**RE: Lot 16 Block 4 Unit 22, S.A.D. 228
Volcano Cliffs Subdivision
5427 Canavio Dr. NW
Grading and Drainage Plan
Engineers Stamp Date: 12/2/2022
Rev. Engineers Stamp Date: 2/24/2022
Pad. Certification Date: 3/22/2022
Certificate of Occupancy Date: 9/28/2022 (D10D003D16)**

Based upon the information provided in your submittal received 2/2/2023, this plan is approved for Certificate of Occupancy by Hydrology

DRAINAGE AND TRANSPORTATION INFORMATION SHEET (REV 6/2018)

HASLAM, VINCENT (CANDELARIA HOMES) - G & D PLAN

DRAINAGE PLAN

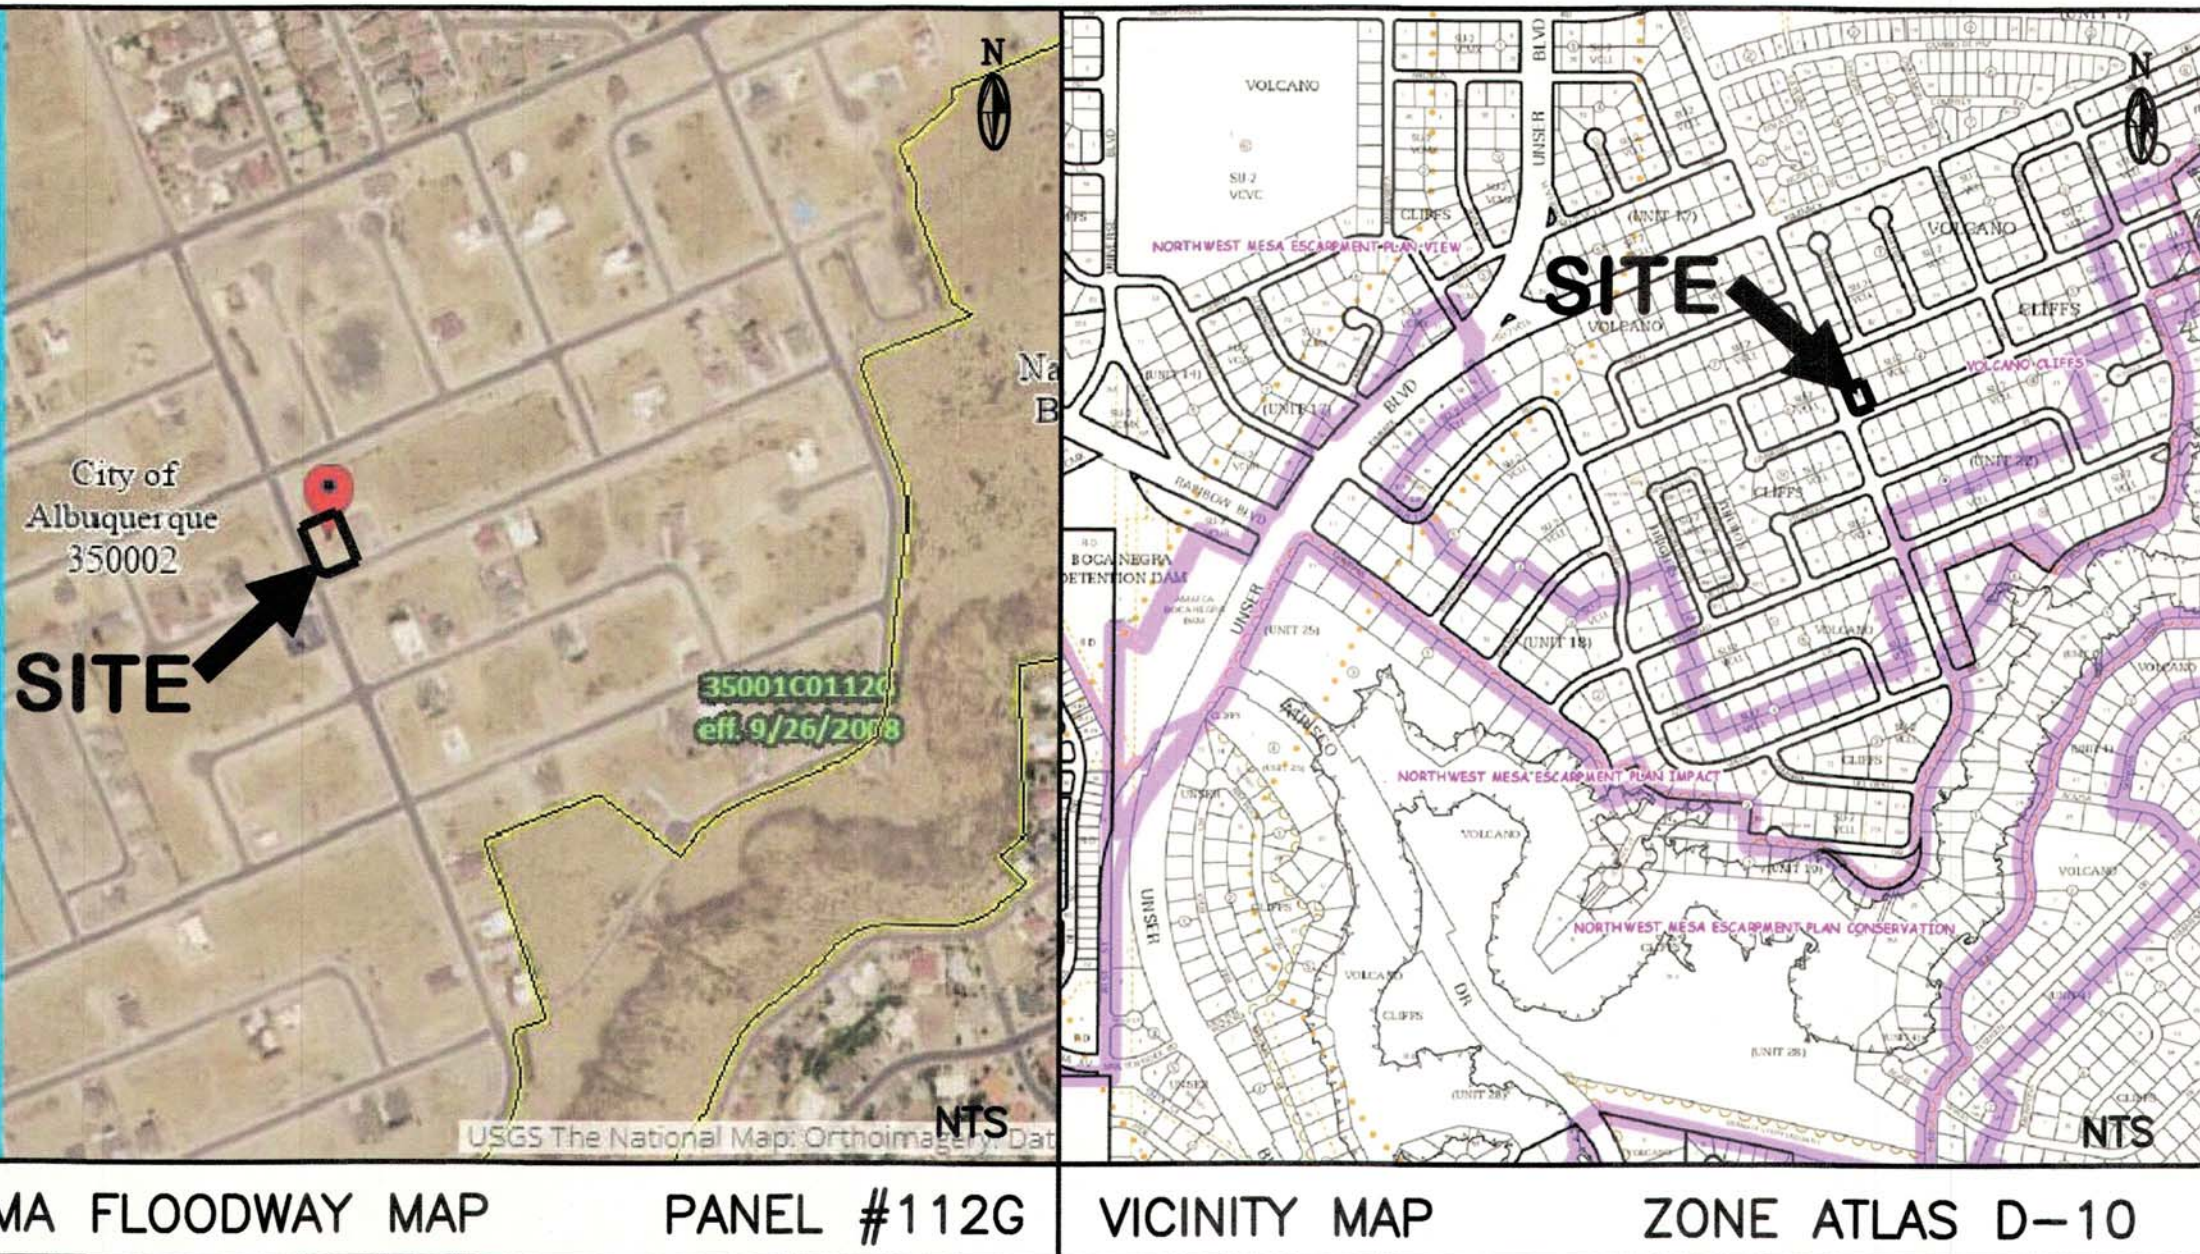
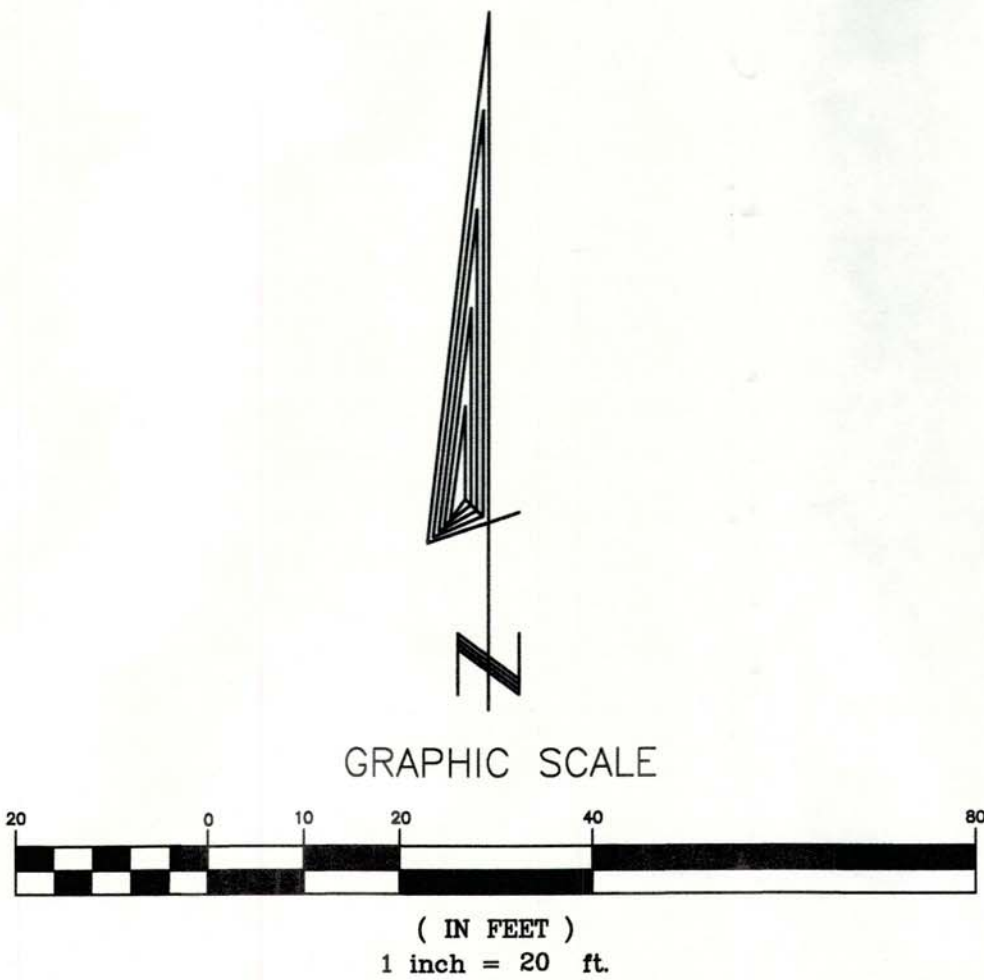
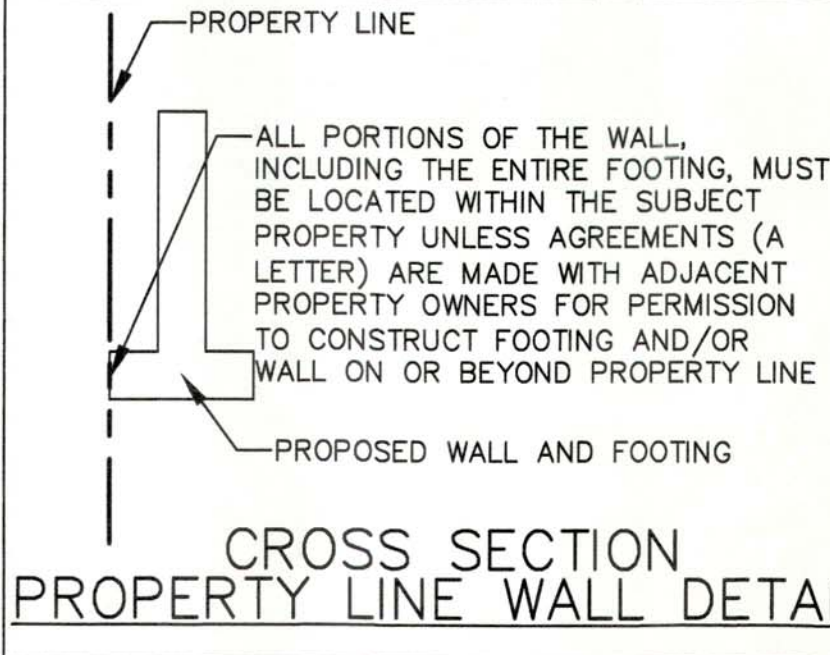
City Note:
Dirt is not allowed to climb the curb, use crusher fines or lumber for this purpose.
